N576NAS1

TECHNICAL BULLETIN

Service Action - Coolant Level Sensor Loose

MODEL:	MODEL YEAR:	VIN:
Defender (LE)	2020-2021	000001-025820

E283547

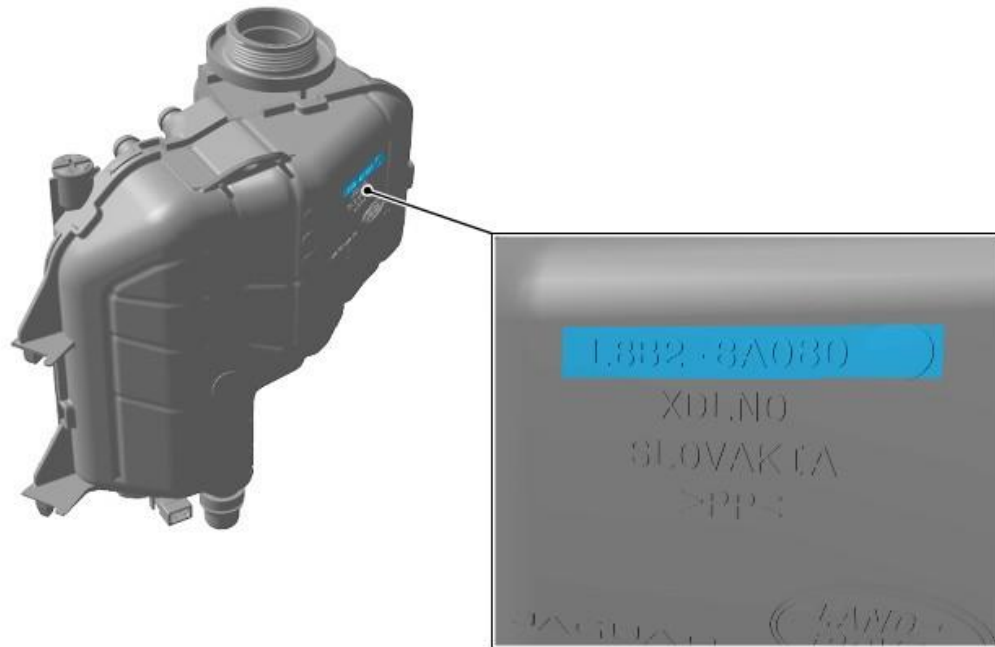
Inspect the coolant expansion tank part number.

- If the coolant expansion tank part number is **L8B2-8A080-AF** or **L8B2-8A080-AG**, reverse steps 1 to 3 and release the vehicle.
- If the coolant expansion tank part number is not **L8B2-8A080-AF** or **L8B2-8A080-AG**, continue to the Service Instruction.
